**Proposal for modification of  
ECE/TRANS/WP.29/GRE/2020/15 (draft of amendment to  
UN Regulation No. 37 (Filament **light sources**))**

The text reproduced below was prepared by TF S/R, on the basis of document ECE/TRANS/WP.29/GRE/2020/15, with the purpose to improve the approval codes for electrical/electronic controls not integrated with the replacement light source in an additional electronics device.

Examples of the arrangement of the approval mark **and specific identification code**

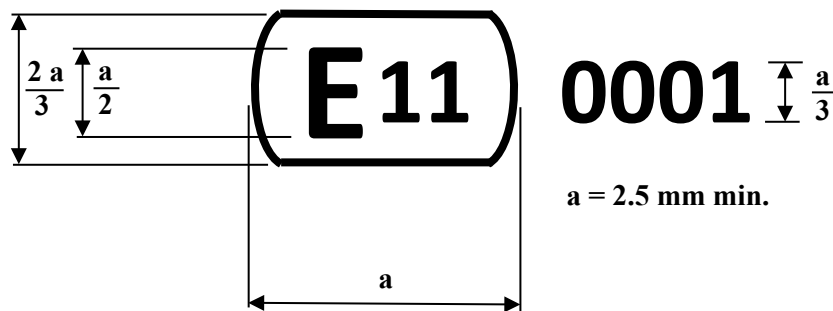
Annex 3, amend to read:

The approval mark above affixed to the light source, preceded by the character “HE”, indicates a high-efficiency LED replacement light source that has been approved in The Netherlands (E 4) under the approval code 1953.

**Æ E4 1953**

The AE device bearing the specific identification code shown above has been approved together with a high-efficiency LED replacement light source approved in The Netherlands (E4) under approval number 1953.”
